Block(s): 16 & 17 Section: 13 District/Division: MAWSON

Issue	Date	Amendment
Project		
Multi Unit Housing		
Site		
blocks 16+17		
section 13,		
Mawson, ACT.		
Title		
Site Plan		
Scale	1:200	Drawn By SA
Date	May 2008	Drawing No. 1284 - A
PETER BYFIELD + Associates Suits A, 34 Taylor Street, Ainsworth NSW 2158 Phone 02 9880 2255 Fax 02 9660 2255

Title
Garage Level Floor Plan & Sections

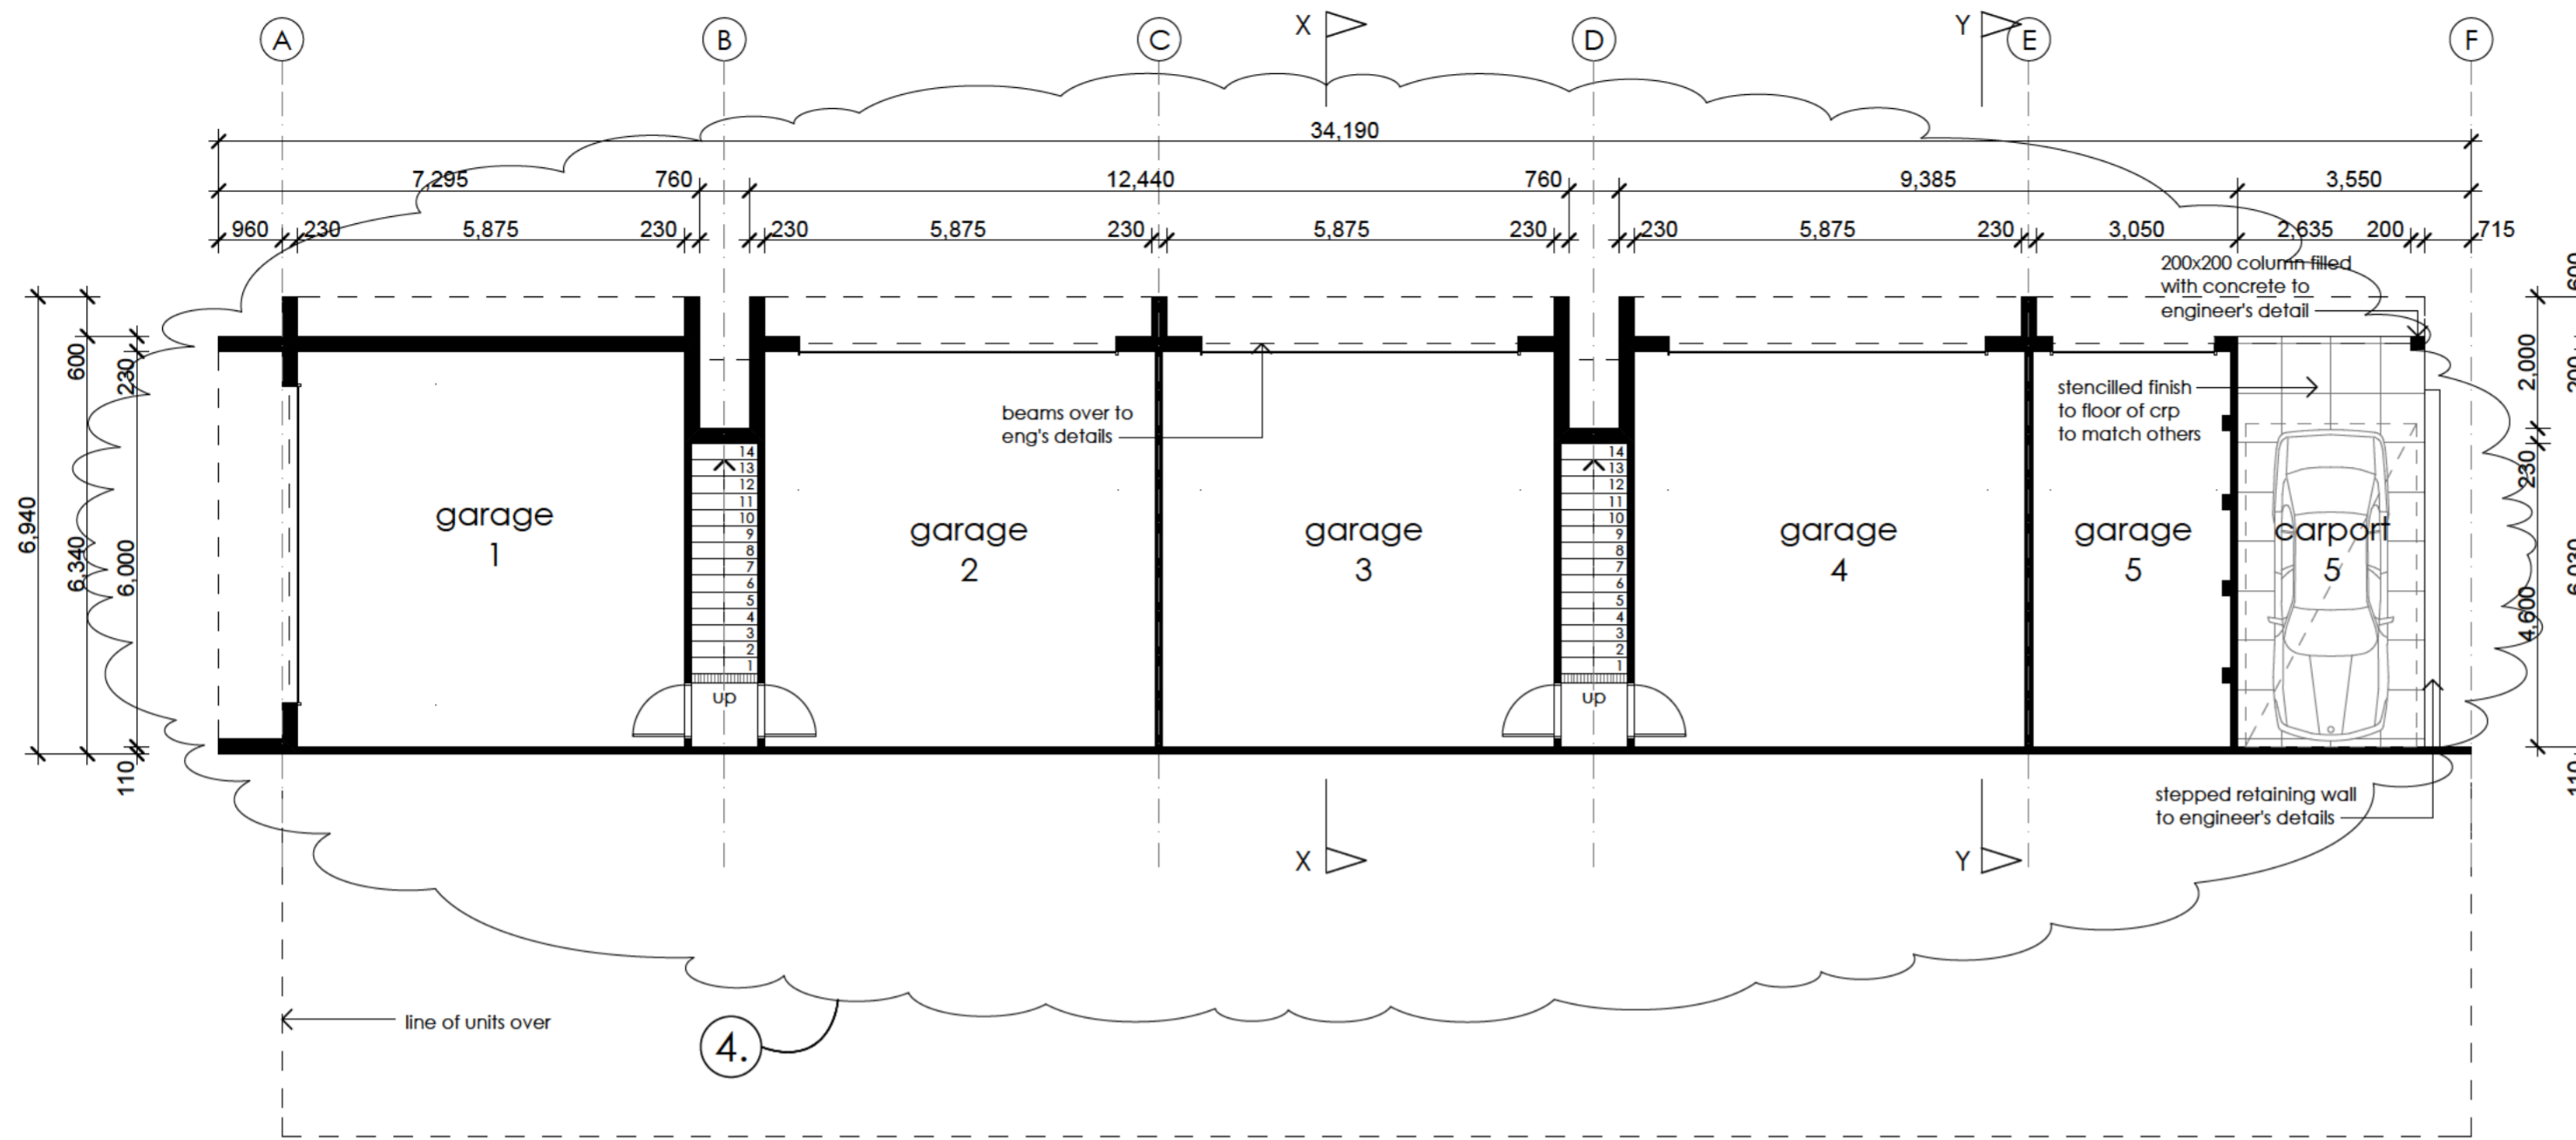
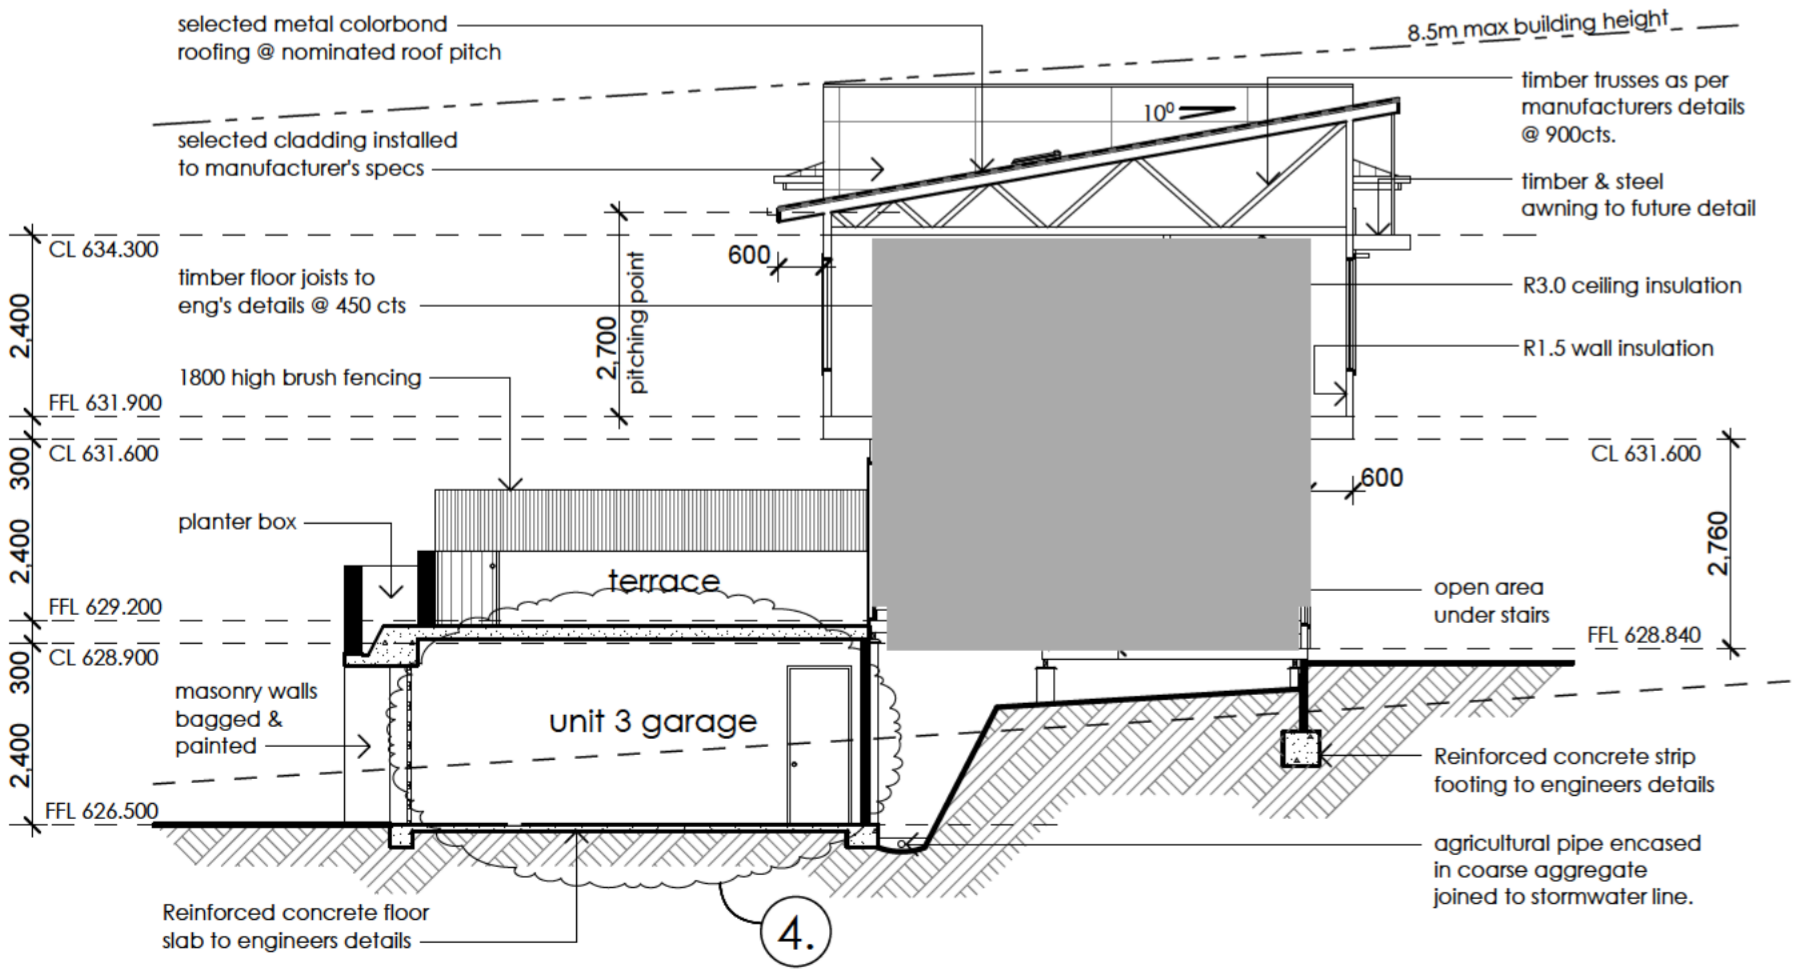
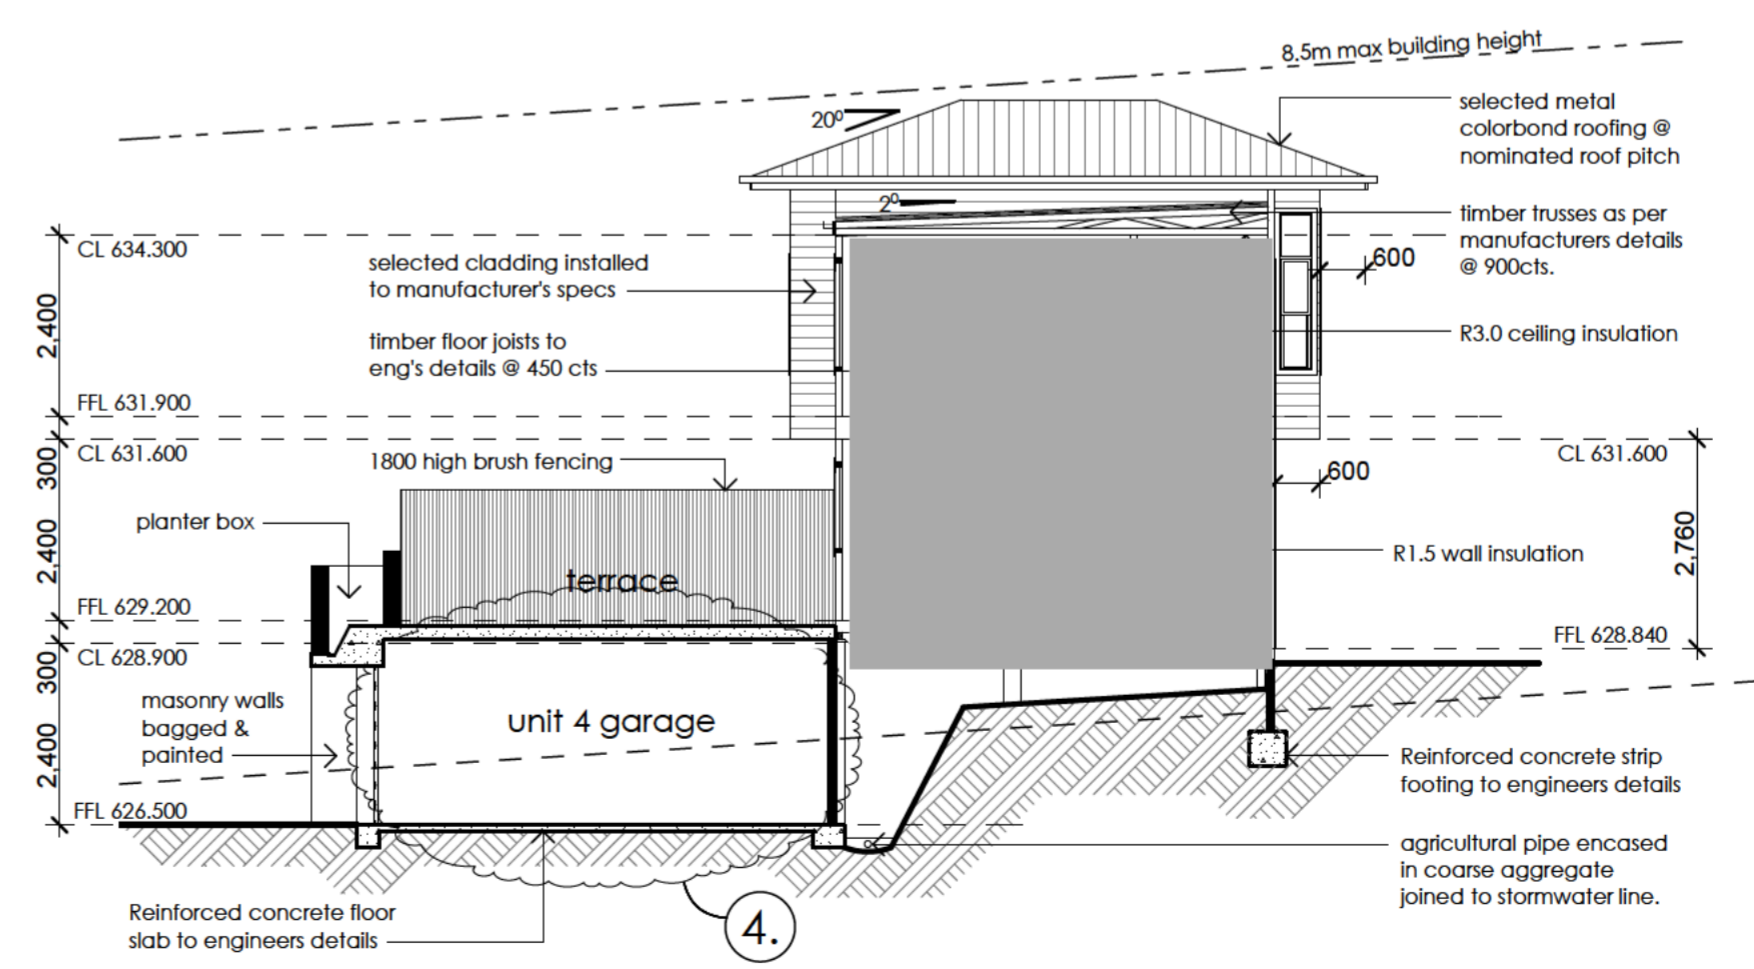
- Provide enclosure for units 6-9 waste bins.
- | Issue | Date | Event |

Title
Additional Site Plans

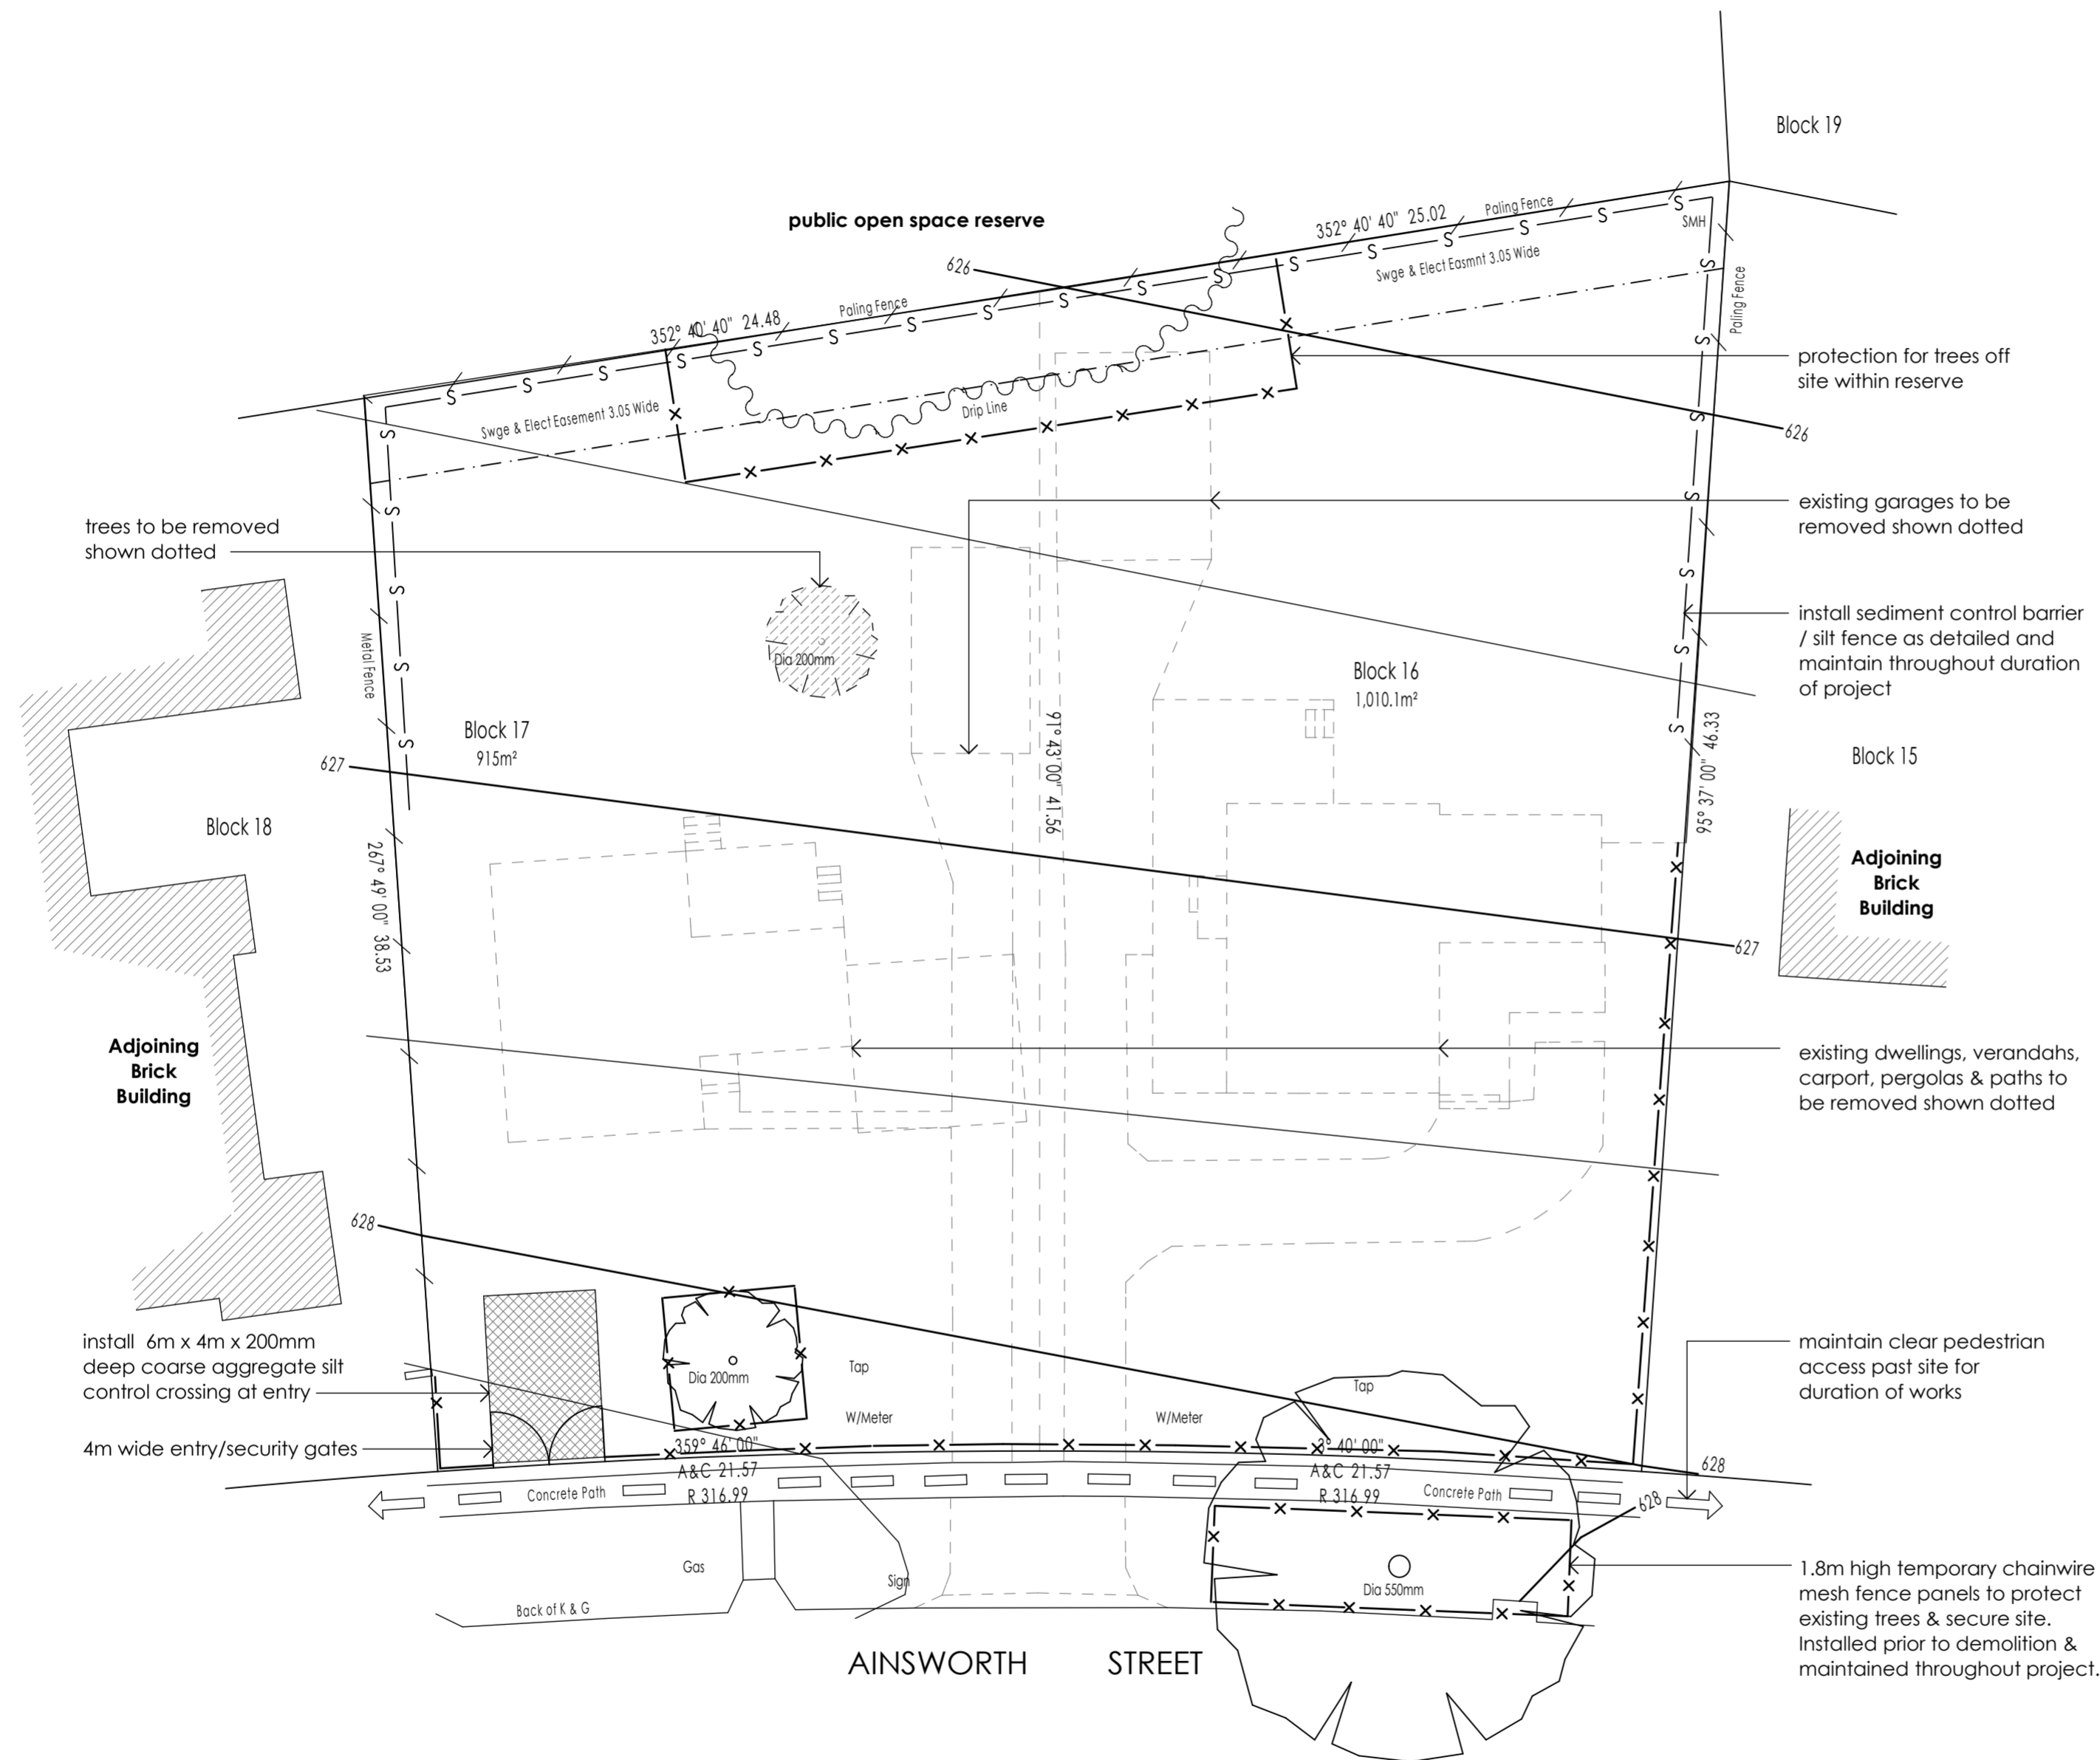
6. Provide enclosure for units 6-9 waste bins.
- | Issue | Date | Event |
